SUBJECT: ADDENDUM #1
IFB # 2017-18-719 Taxiway A Rehabilitation - Bid Package 1 at Myrtle
Beach International Airport (MYR)

ADDENDUM #1

**STORMWATER MANAGEMENT RECTANGULAR JUNCTION BOX
(STRUCTURE D106)**

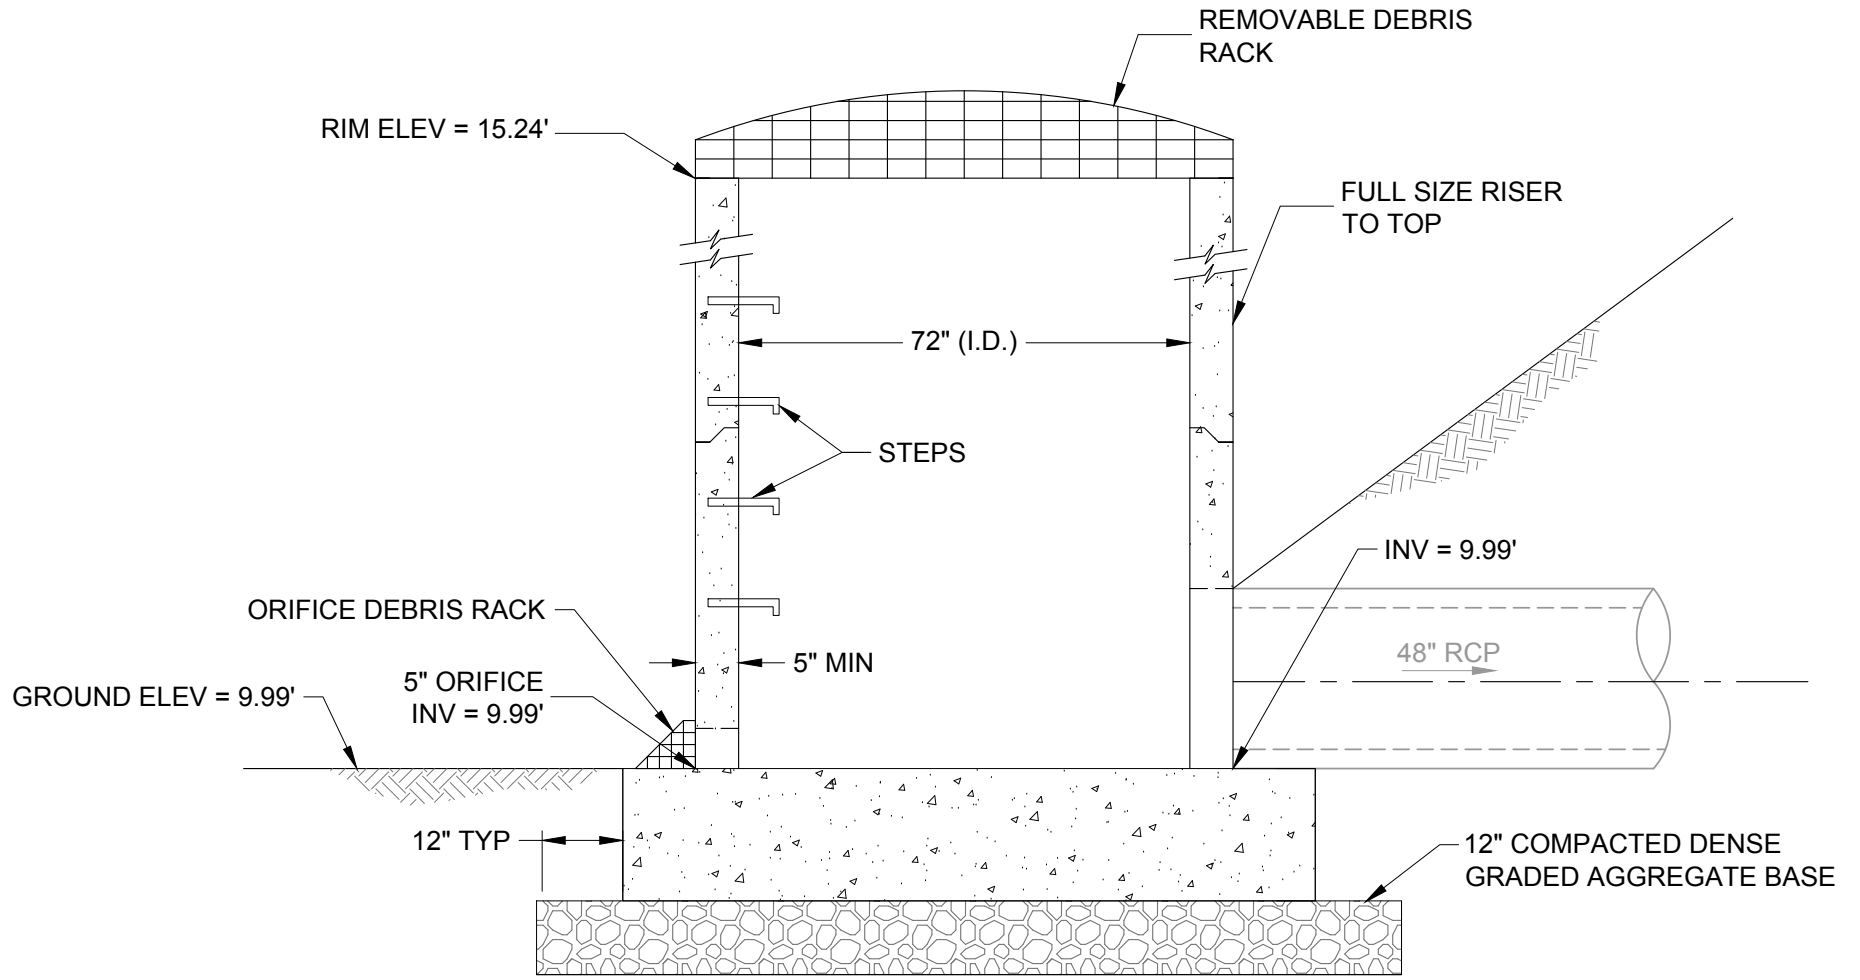
6. **REPLACE** the "STORMWATER MANAGEMENT RECTANGULAR JUNCTION BOX (STRUCTURE D106)" detail with the revised "STORMWATER MANAGEMENT RECTANGULAR JUNCTION BOX (STRUCTURE D106)" detail shown in Exhibit No. 82-1 of Addendum #1.

TYPE 3 PCC TAXIWAY PAVEMENT SECTION

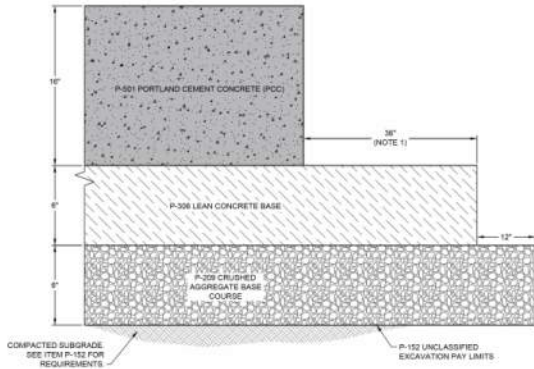
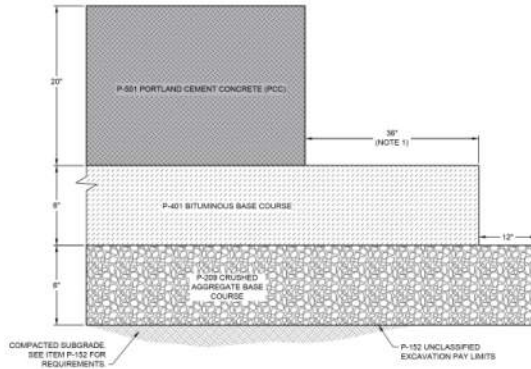
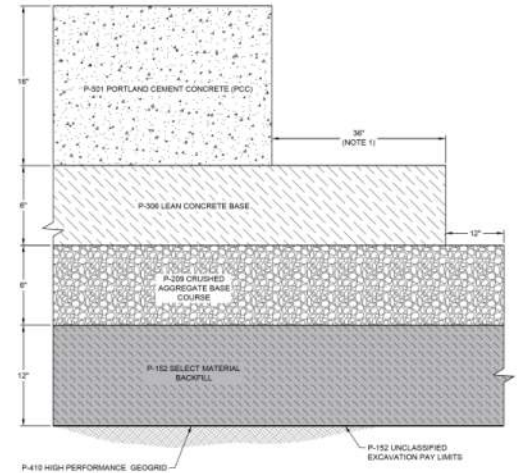
8. ADD the following Note 4 to the "TYPE 3 PCC TAXIWAY PAVEMENT SECTION" detail:

"4. EXCAVATION REQUIRED TO PLACE THE P-152 SELECT MATERIAL BACKFILL SHALL BE PAID FOR UNDER THE P-152 UNCLASSIFIED EXCAVATION PAY ITEM."

Question #4: Can the contractor use P-304 CTB base in lieu of P-306 econocrete? If so can you please provide the P-304 specification.

Answer: *Yes, as stated in Note 2 of the "Type 1 PCC Taxiway Pavement Section" and "Type 3 PCC Taxiway Pavement Section" details on Sheet 92 of 192, "The Contractor may*

substitute P-304 Cement Treated Base Course for the P-306 Lean Concrete Pavement. Payment for the P-304 Cement Treated Base Course, if used by the Contractor, in lieu of P-306 Lean Concrete Pavement, will be made at the contract unit price per square yard for P-306 Lean Concrete". Specification Item P-304 Cement Treated Base Course was included in the As-Bid Specifications.

TAXIWAY A REHAB (BID PACK 1)		AIP NO. 3-45-0065-PENDING-2018	JOB NO. 18003
FIBER OPTIC RELOCATION PLAN		DRAWN BY: DWS	SHEET 112
		DESIGNED BY: DES/RTS	OF 192
MYRTLE BEACH INTERNATIONAL AIRPORT		SCALE: 1" = 60'	DATE: MAY 2018

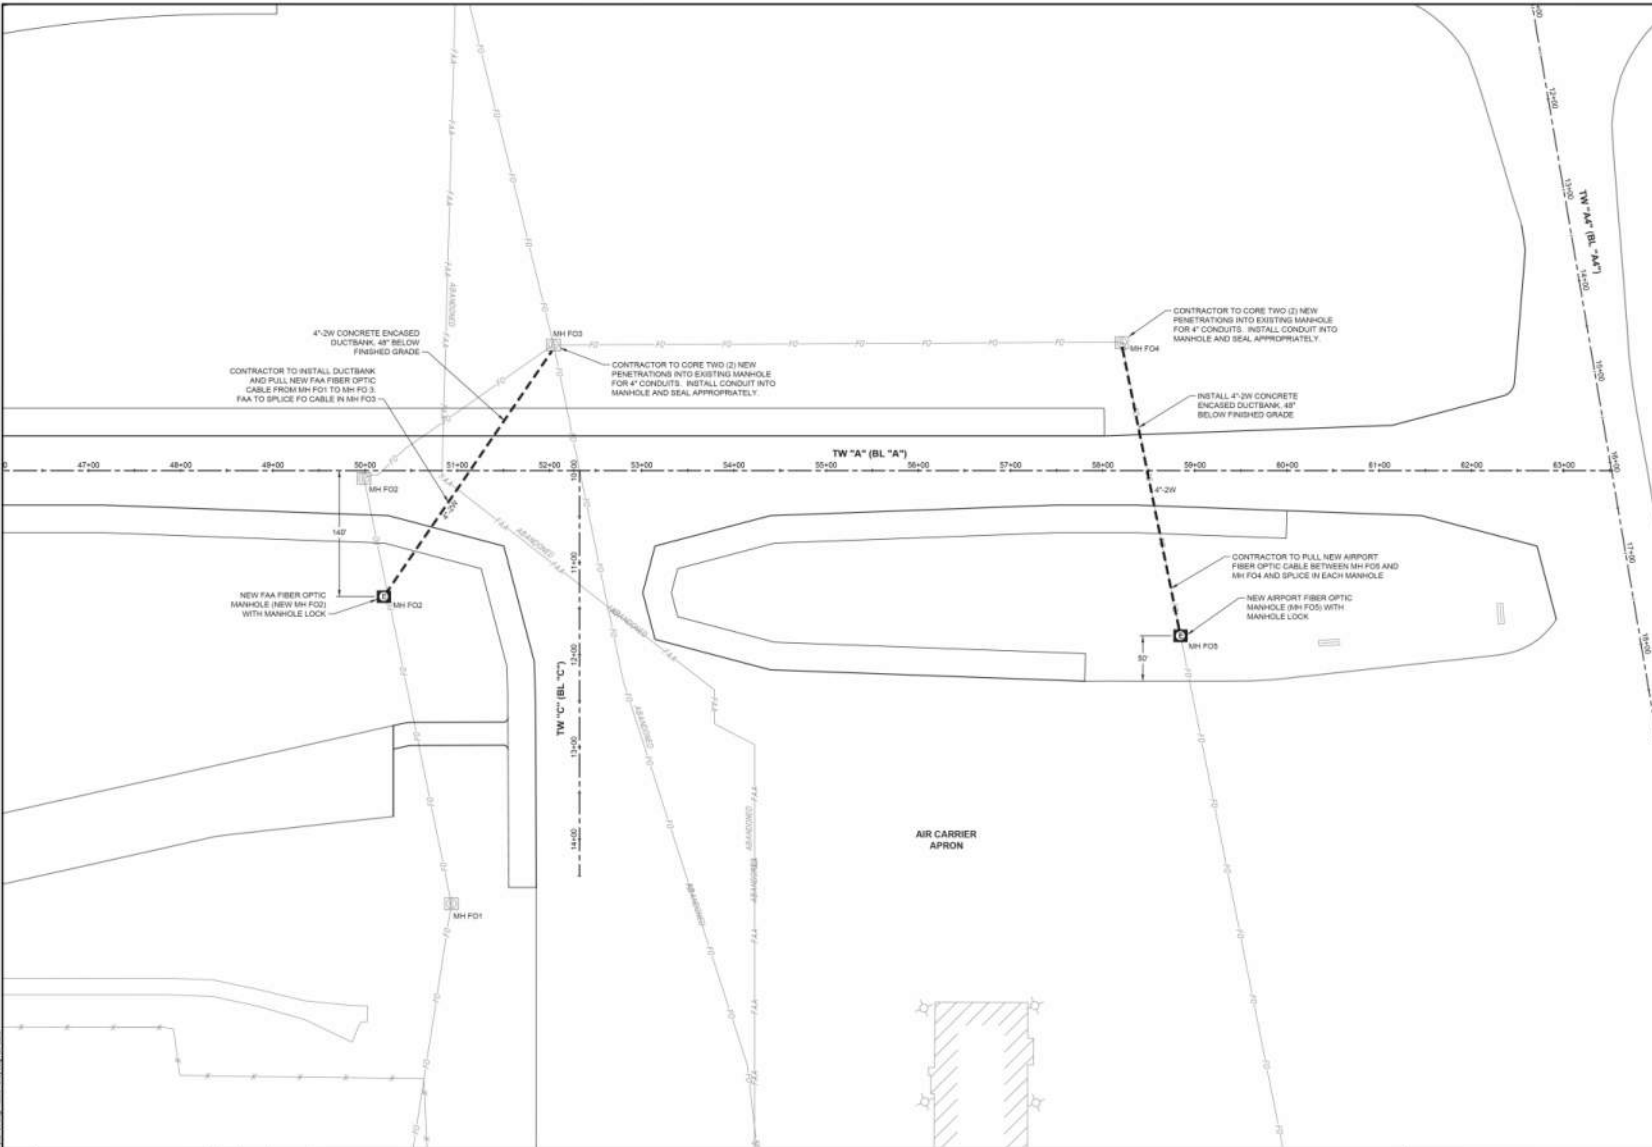
9. ADD the following Note 3:

"3. THE FAA FIBER OPTIC CABLE IS 12 STRAND SINGLE MODE."

10. ADD the following Note 4:

"4. THE AIRPORT FIBER OPTIC CABLE IS 96 STRAND SINGLE MODE."

11. ADD the following Note 5:

"5. THE CONTRACTOR SHALL NOTIFY THE ENGINEER AND OWNER 24 HOURS IN ADVANCE OF DISRUPTION OF SERVICE TO THE AIRPORT FIBER OPTIC CABLE. SERVICE SHALL BE RESTORED WITHIN 8 HOURS OF DISRUPTION."
